# Illustrated Parts List - IPL Update

**H550XP/XPG**

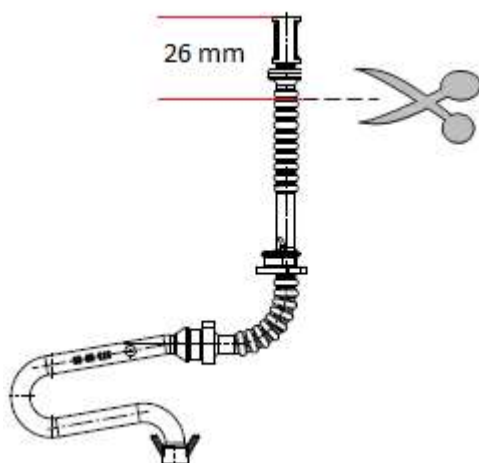
1. New Carburetor, kit AT-12 587 08 48-06 added. Improved acceleration and idle stability.
2. New Fuel hose 577 50 41-01 is 26 mm shorter than old 573 99 35-03 to fit new connection on Carburetor AT-12.
3. Choke control changed to secure correct assembly.

When you don't want to change to the new fuel hose included in kit, Carburetor.  
Cut your old hose like this:
